FDR AMENDMENT 2:
06/22/26

Bradley Heights Filing 3 & 4 Final Drainage Report Amendment #2

STM-REV26-0584 (FDR Amendment #2 Pending)

June 2026

STORMCAD LAYOUT

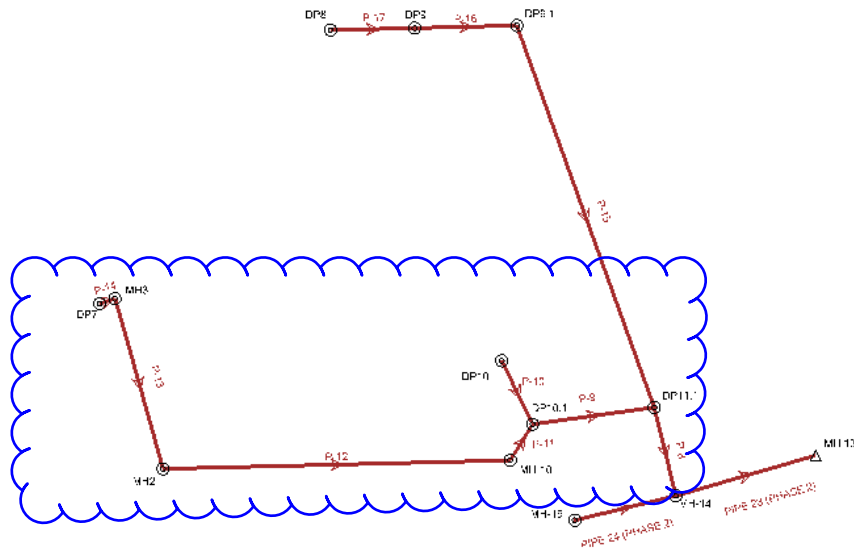
This FDR for Bradley Heights Filing 3 & 4 is being amended due to relocating proposed private storm within private Wedemeyer Court outside of the roadway to mitigate high cost of secondary containment between proposed water and sanitary mains. The storm remains private. The following items are revised with this second amendment:

1. Revisions to the narrative including four step process discussion and updates to the 2026 Drainage & Bridge Fees
2. Revisions to the following *Appendix C- Hydraulic Calculations and Appendix F – Drainage Maps*. (revisions clouded on each sheet)
 - a. Storm CAD Layout (revisions clouded)
 - b. 5-YEAR SCENARIO -Conduit Tables, Element tables, HGL Profile Reports
 - c. 100-YEAR SCENARIO -Conduit Tables, Element tables, HGL Profile Reports
 - d. Proposed Drainage Map – Sheet 2
